REMARKS/ARGUMENTS

Amendments to the Drawings:

The attached eight (8) sheets of drawings include changes to Figs. 1-3, 8, 9, 11, 13, 15 and 16. These eight sheets replace the original sheets including Figs. 1-3, 8, 9, 11, 13, 15 and 16. The changes are detailed below:

FIG. 1

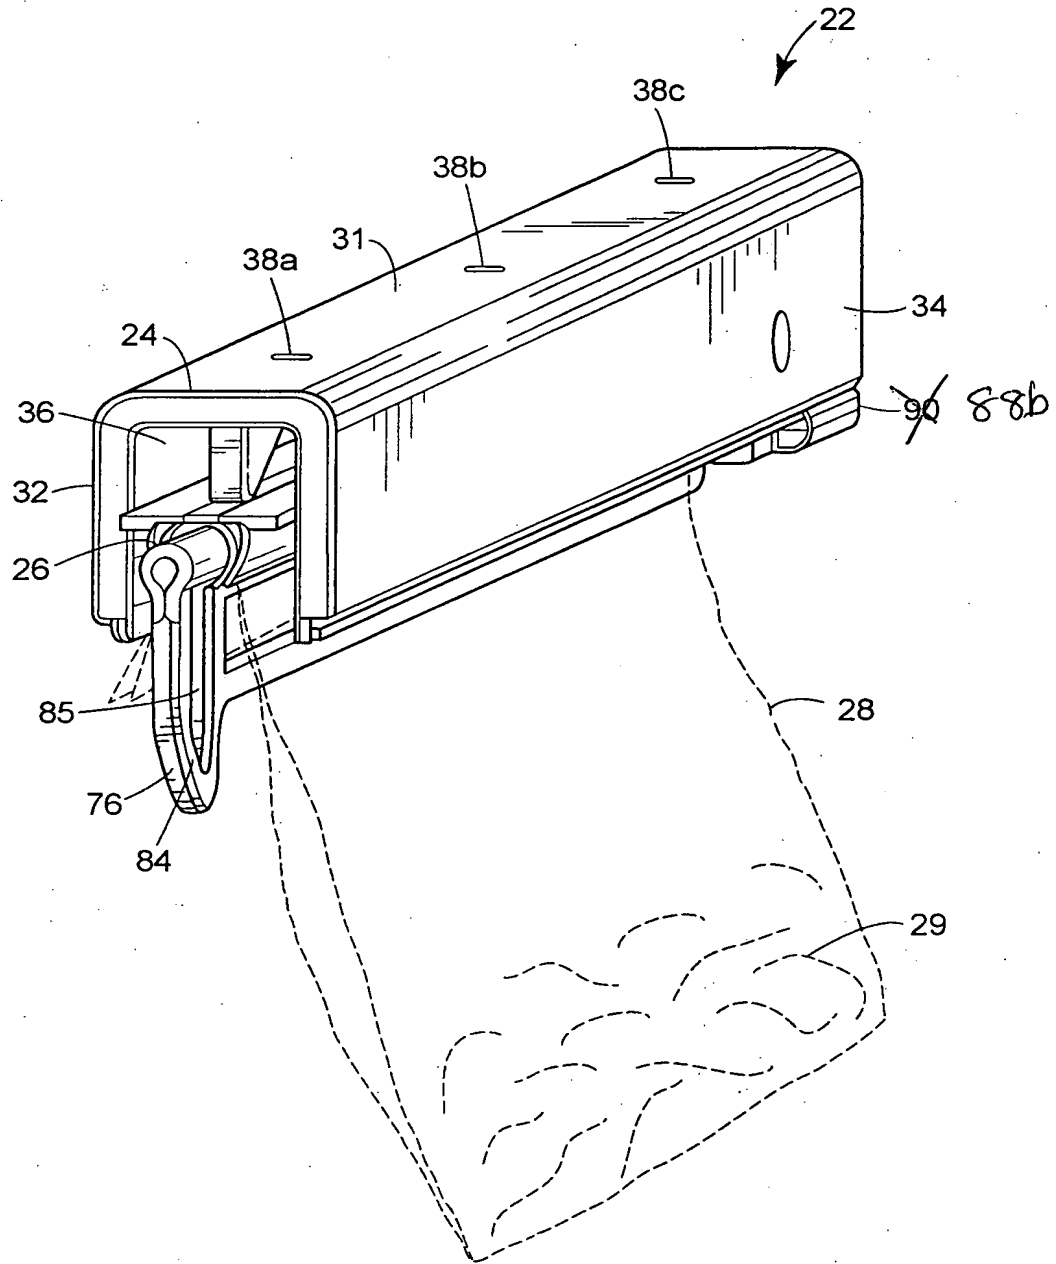
In Fig. 1, "90" has been changed to --88b--.

FIG.2

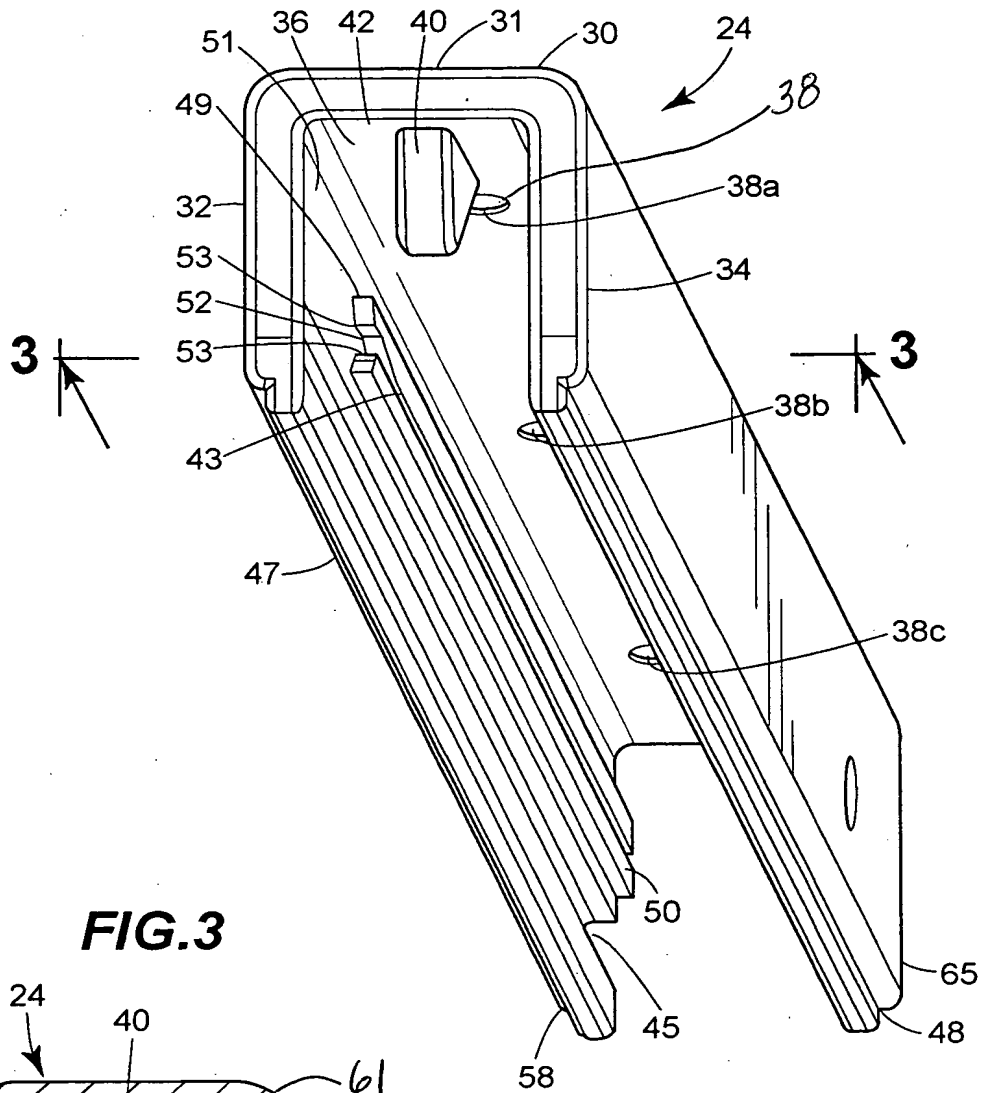
In Fig. 2, "38" has been added;

FIG.3

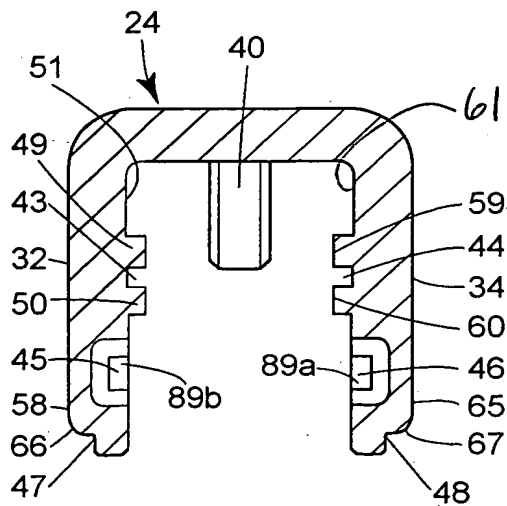
In Fig. 3, "61" has been added;

FIG. 8

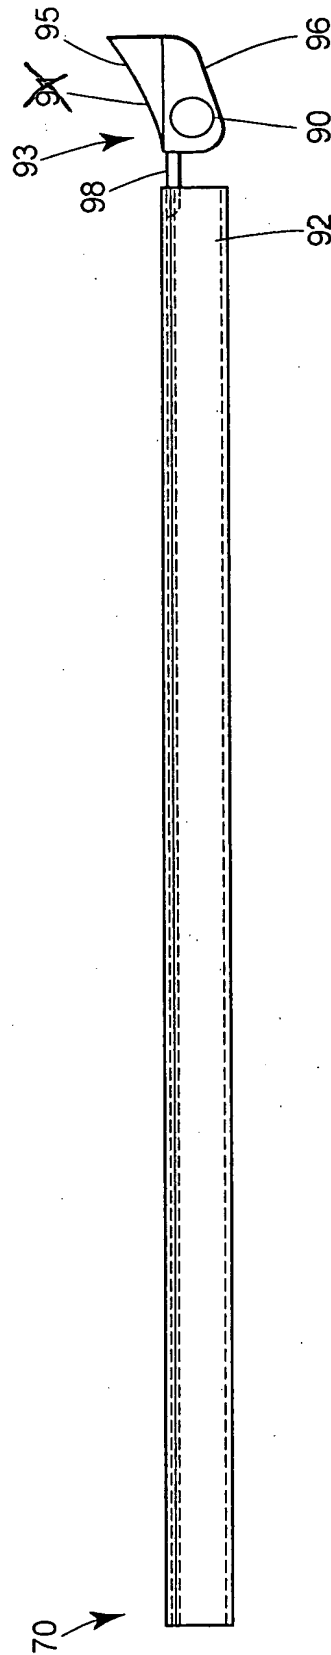
In Fig. 8, "91" has been deleted;

FIG. 9

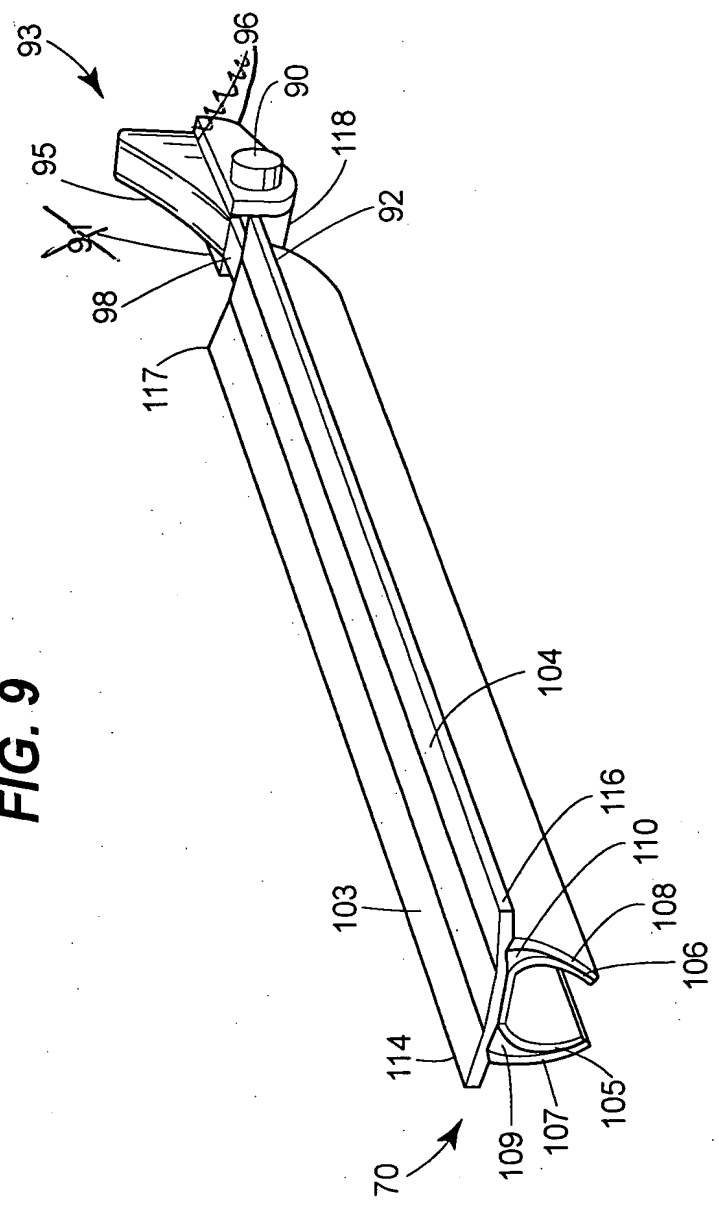
In Fig. 9, "91" has been deleted and the lead line from 96 has been moved;

FIG. 11

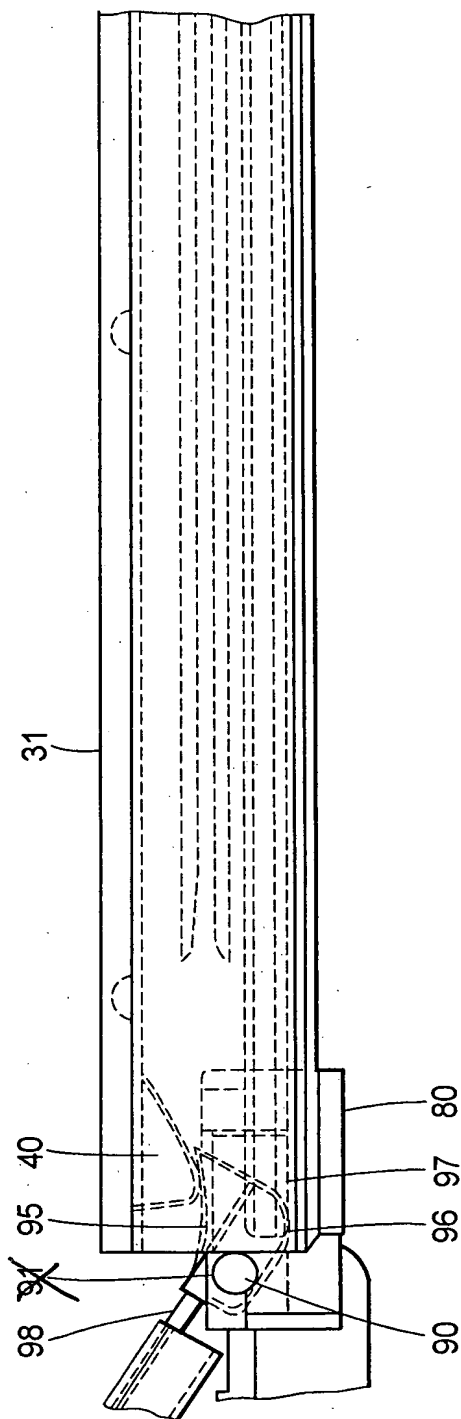
In Fig. 11, "91" has been deleted.

FIG. 13

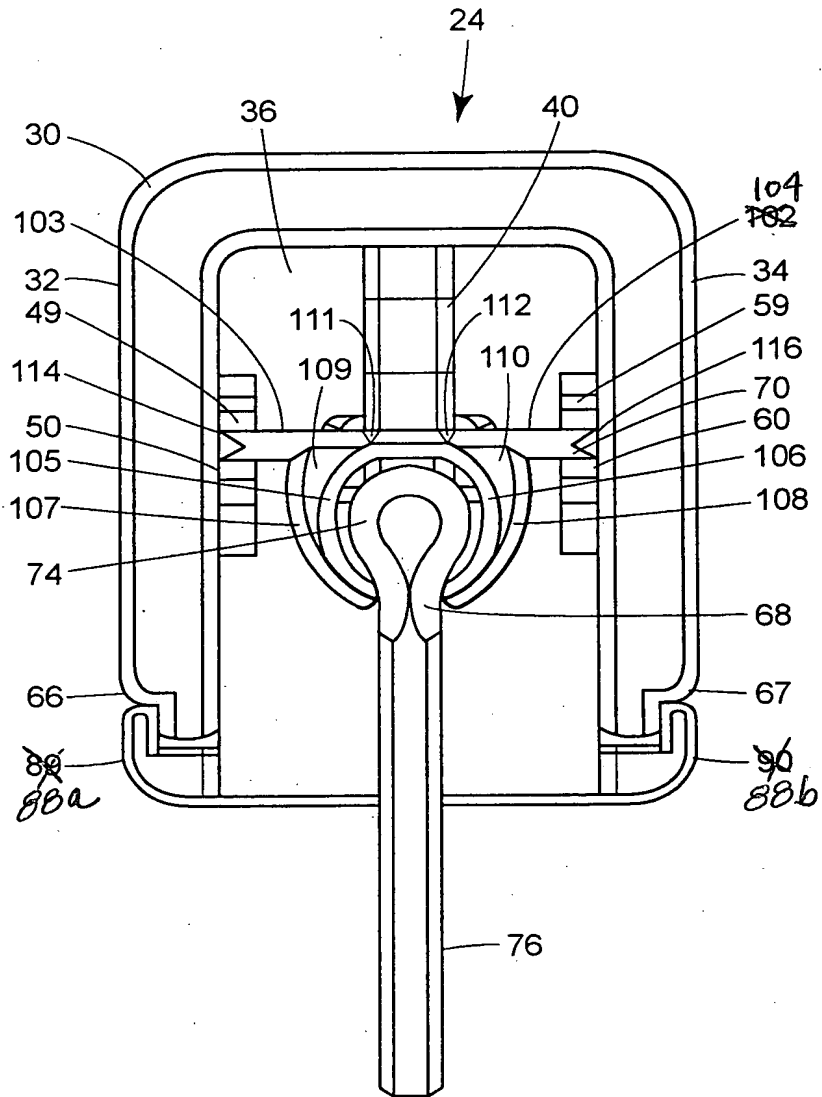
In Fig. 13, "102" has been changed to --104--;

"89" has been changed to --88a--; and

"90" has been changed to --88b--;
